SUBDIVISION REVIEW SHEET

CASE NO.: C8-2016-0216.0A**ZAP DATE:** January 2, 2018**SUBDIVISION NAME:** Allen Terrace Subdivision**AREA:** 1.98**LOT(S):** 5**OWNER/APPLICANT:** (John Dan McMahan III and Artemis Land Partners)**AGENT:** (Rivera Engineering)**ADDRESS OF SUBDIVISION:** 1401 Allen Road**GRIDS:** MF22**COUNTY:** Travis**WATERSHED:** Eanes Creek**JURISDICTION:** Full-Purpose**EXISTING ZONING:** SF-2**MUD:** N/A**NEIGHBORHOOD PLAN:** N/A**DISTRICT:** 8**PROPOSED LAND USE:** Single Family**ADMINISTRATIVE WAIVERS:** n/a

SUBJECT: C8-2016-0216.0A Allen Terrace Subdivision, Flag Lot variance request

DETAILED WATER & WASTEWATER SERVICE PLAN

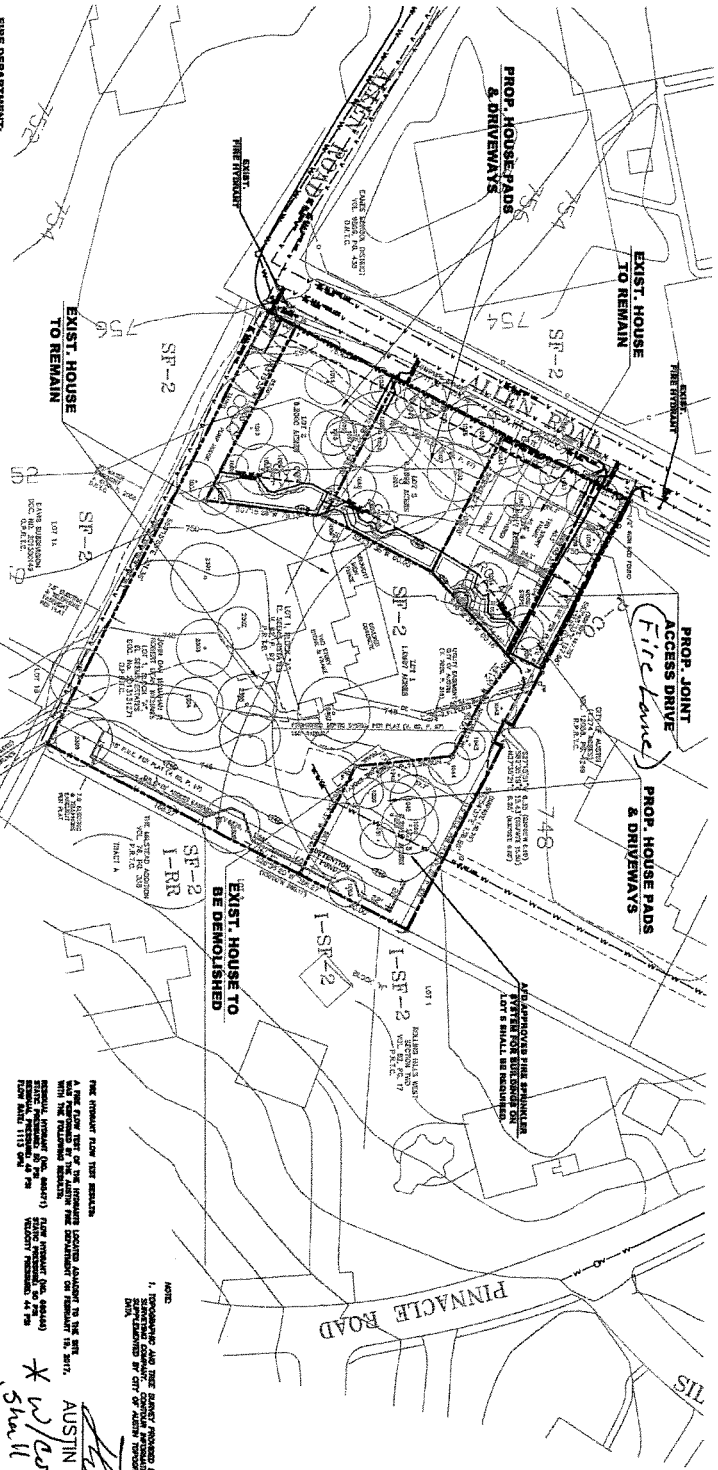
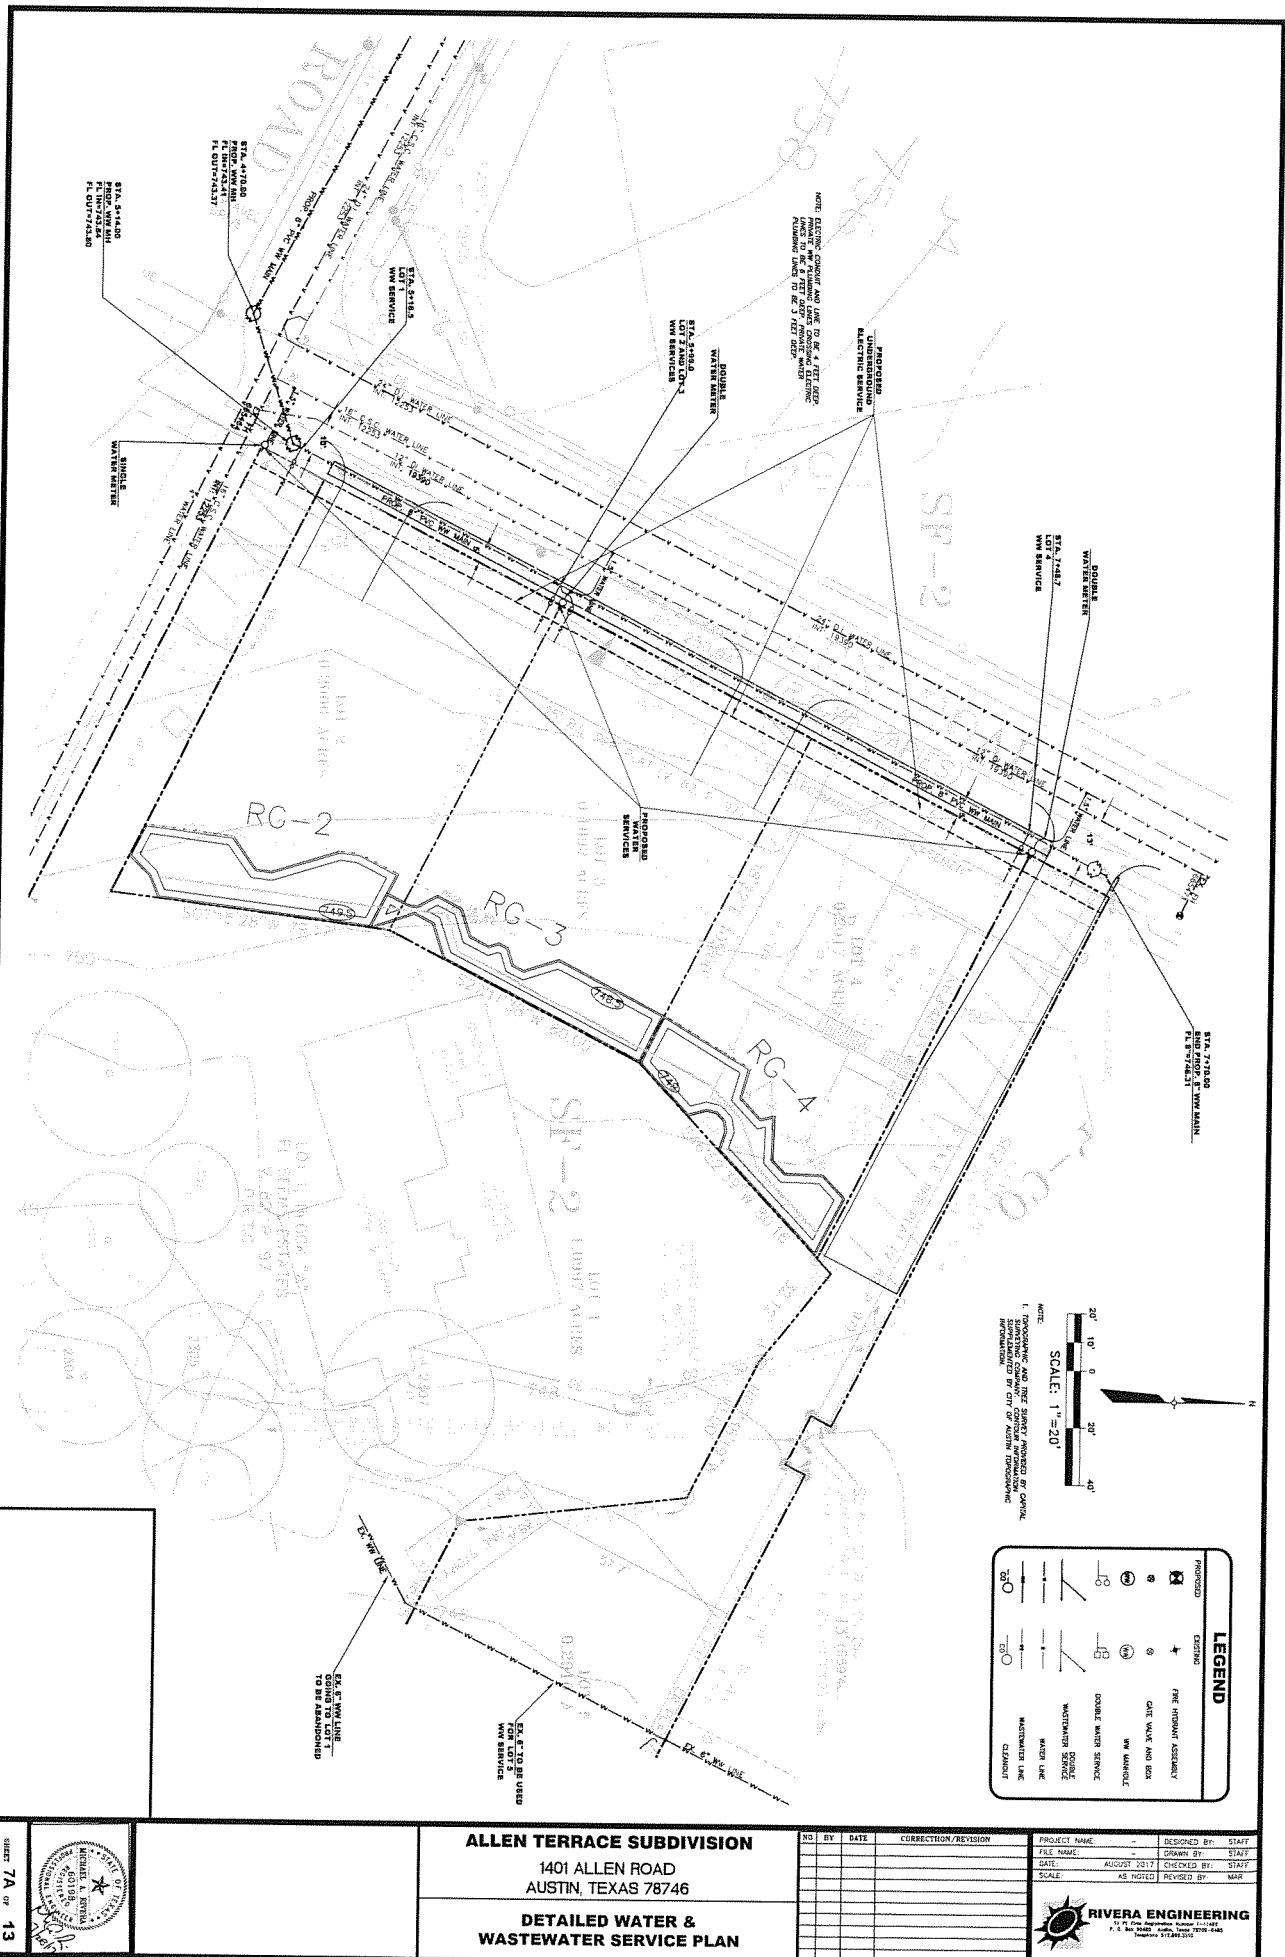
Handwritten notes:
* w/ comment - pavement etc. in
should be provided with subdivision
driv's; don't put
blow permits.
DATE 8/2/2017
